Revision of Manuscript Number: IEEE-TPWRS-01391-2021, version 1 January 2, 2022
Journal: IEEE Transactions on Power Systems
Author: Abhishek Halder, Kenneth F. Caluya, Pegah Ojaghi, Xinbo Geng

Response to decision:

Response to AE:

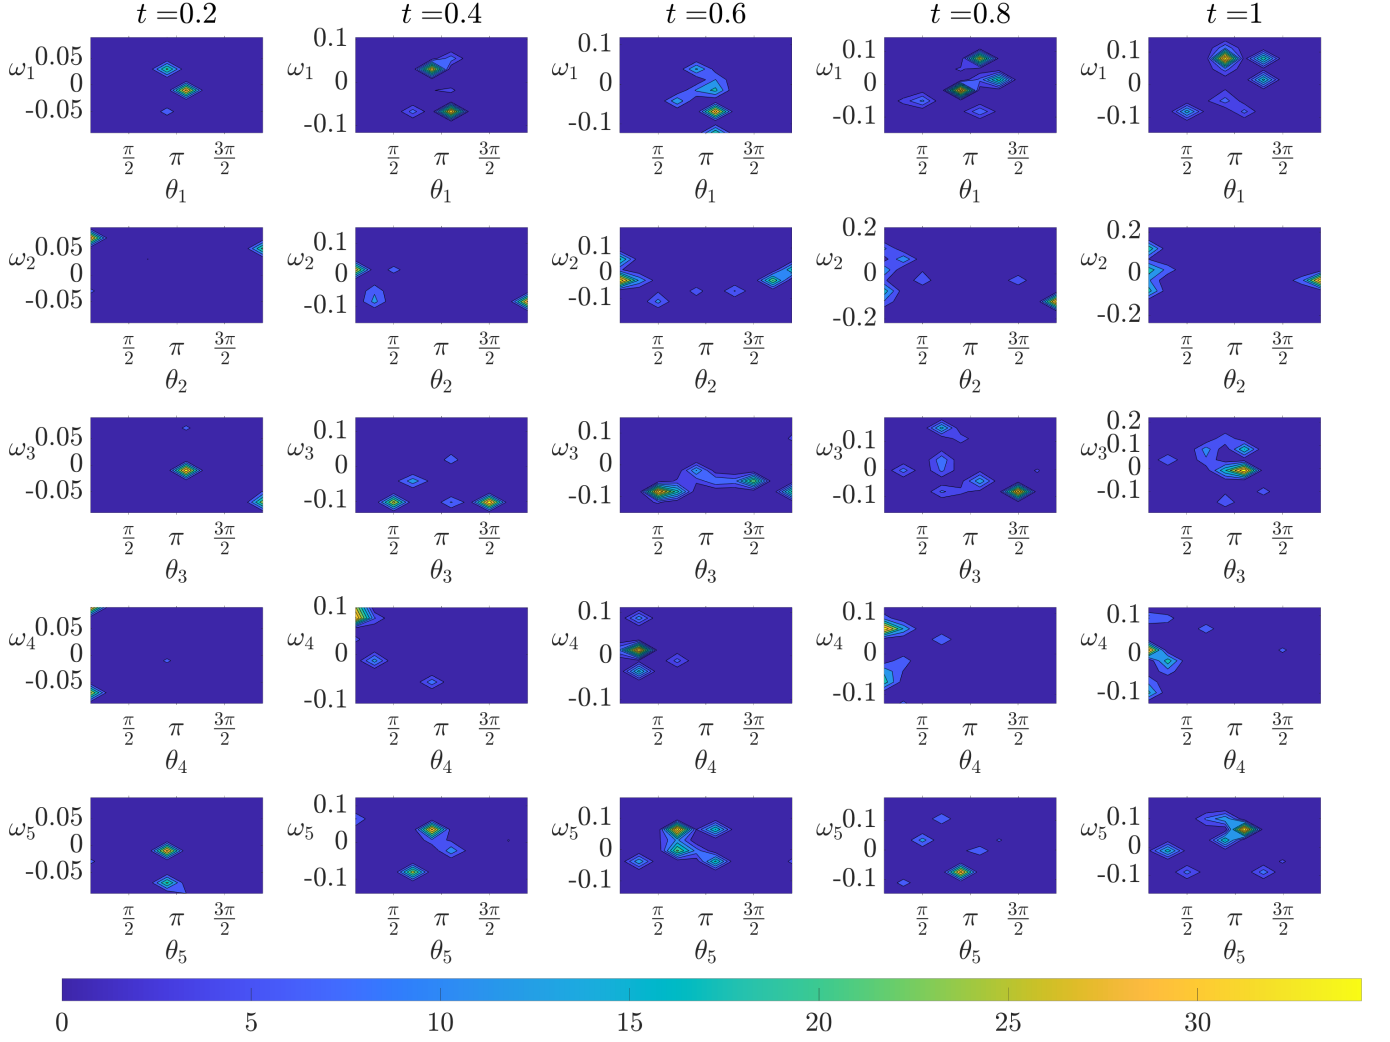
Figures 5 and 6 are unreadable.

Response: Thanks for this comment. In the previous version, the strict 10 page limit enforced small figure sizes. In the revised manuscript, Figures 5 and 6 are made larger. Also, the Fig. 6 in the revised manuscript shows the transient (θ_i, ω_i) bivariate marginals for all the five generators in Case II; the previous version showed the same only for the generator 4 (bus 6). We believe these changes have improved clarity.

Regarding the style of plots, we had considered plotting the bivariate marginals as planar contour plots (as in Fig. 1 in this rebuttal document) but decided against it because of the following two reasons.

First, in our opinion, this kind of plot is scientifically misleading as they hide the fact that these bivariate marginal PDFs are not really supported on the plane, or the subsets thereof, but instead have cylindrical supports. Our message that the proposed method explicitly accounts this manifold geometry in the computation, would be missed had we chosen to make the plots as per populist cognitive bias on behalf of the readers. That the planar plots evoke a sense of familiarity cannot be a scientific argument in favor of it.

Second, the planar contour marginal plots require additional mental efforts from the readers to correctly parse the statistical information conveyed. For instance, consider the fourth column, second row subplot in Fig. 1 in this rebuttal document. It is upon the reader to parse that the two high probability regions on the left and right of that subplot are actually referring to the same angular high probability region around $\theta_2 = 0$ rad, thanks to the periodic boundary condition on the angular variable. Our philosophy of technical communication is that the onus is on the authors, not on the readers, to clarify the scientific information as correctly as possible. And yes, we are aware that many papers in the power system literature make plots

in the rectangular domain ignoring the manifold nature of the support, which in our experience, continue to add pain to the graduate students and beginning researchers trying to decipher the statistical meaning conveyed in those plots. We prefer ours not be contributing to the accrual of such pain, and instead make plots that depict the variables as they are.
